## SERVICE TECHNICAL INFORMATION

### ONE POINT REPAIR

UTSUNOMIYA, OCTOBER 15, 1997  
REF. NO.: SI-97-034  
CUSTOMER RELATIONS & SERVICE DIV.

MODEL : DX-Z9450M

PT C.B Pattern side

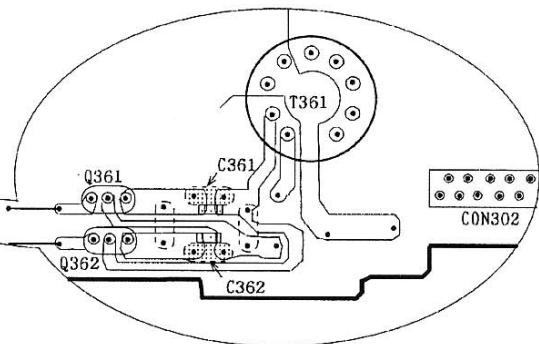
REMEDIES : TAITSU-product or NISSEI-product mylar capacitors C361 & C362  
(0.027μF/50V) are employed in the PT PWB. Replace TAITSU capacitors  
with NISSEI capacitors regardless of presence/absence of the above problem.  
\* Manufacturer-name indication on capacitors:

Ref. No.	Part name	Part code
C361/362	CAP M 0.027-50J	88-700-890-010
